State of New Mexico
 Energy, Minerals and Natural Resources

Form C-103
 Revised July 18, 2013

| 7. Lease Name or Unit Agreement Name STATE 23 A | |

State 23 A #1 – P&A Procedure

Proposed Wellbore Diagram:

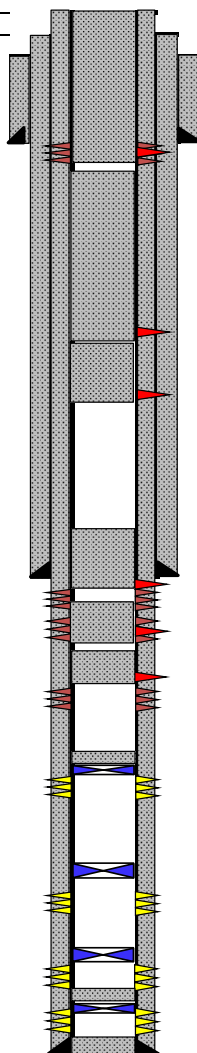
****SEE ATTACHED COA's****

Run CBL
